**City of Portland, Maine – Building or Use Permit Application** 389 Congress Street, 04101, Tel: (207) 874-8703, FAX: 874-8716

DATE: 26 July 96 ADDRESS: 240 Sherwood ST  
 REASON FOR PERMIT: To rebuild Garage  
 BUILDING OWNER: Tenni Gilpatrick  
 CONTRACTOR: owner APPROVED: \*1 \*20  
 PERMIT APPLICANT: \_\_\_\_\_ DENIED: \_\_\_\_\_

REASON FOR PERMIT: rebuild garage in place

20' x 26' Garage

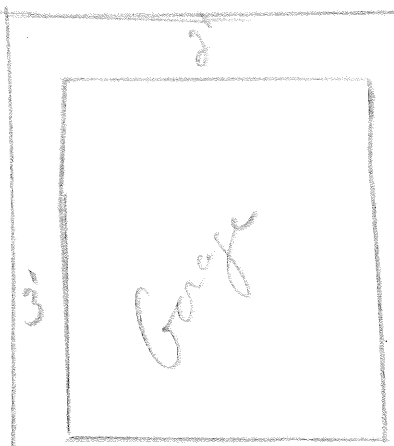
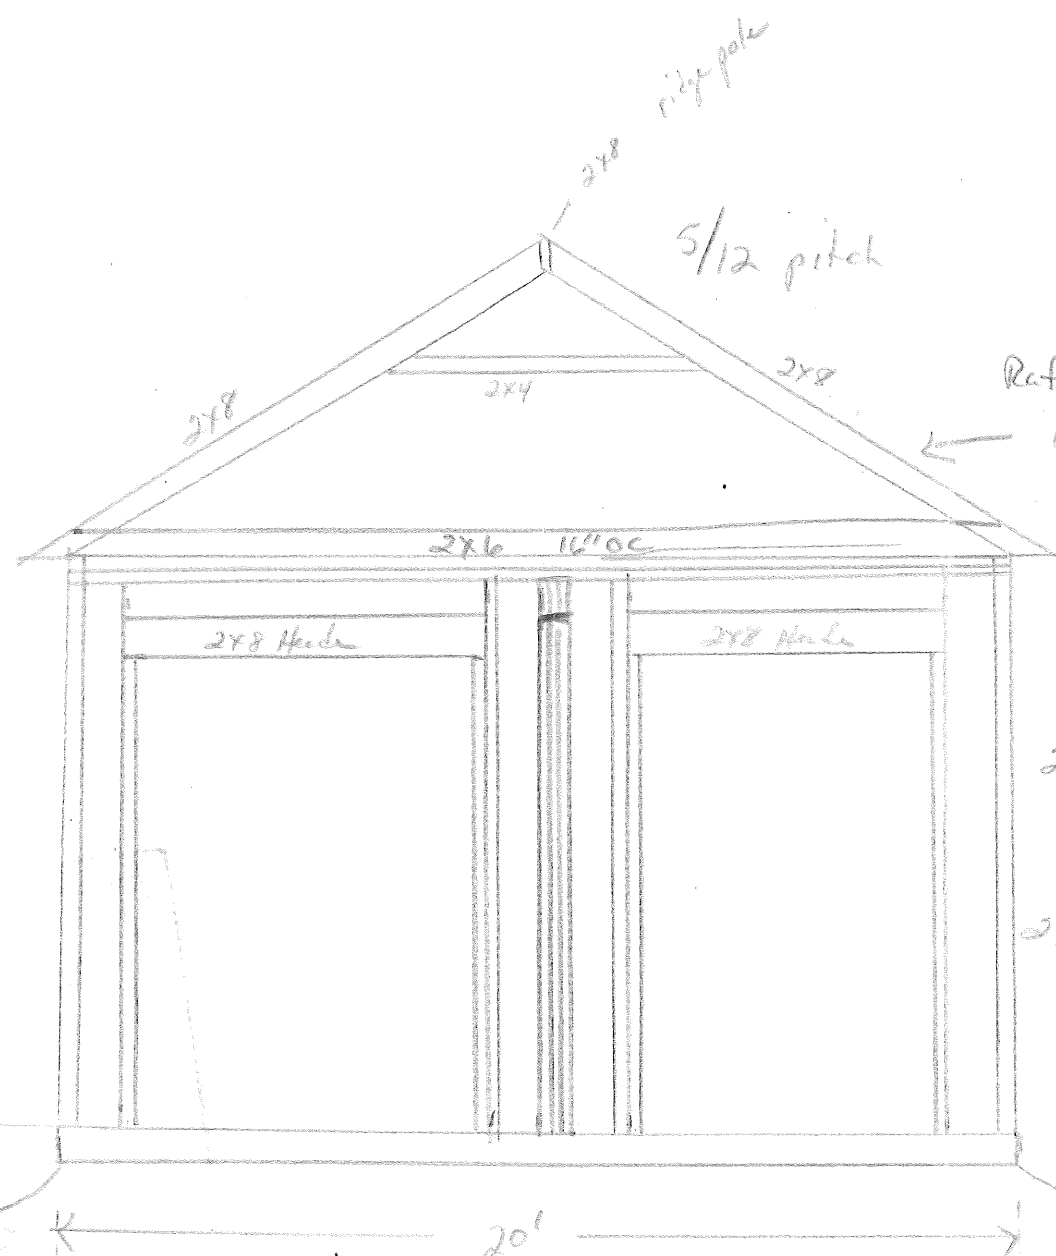
3. All the conditions placed on the original, previously approved, permit issued on \_\_\_\_\_ are still in effect for this amendment.
4. Your present structure is legally nonconforming as to rear and side setbacks. If you were to demolish the building on your own volition, you will **not** be able to maintain these same setbacks. Instead you would need to meet the zoning setbacks set forth in today's ordinances. In order to preserve these legally non-conforming setbacks, you may only rebuild the garage in place and in phases.

→ See conditions
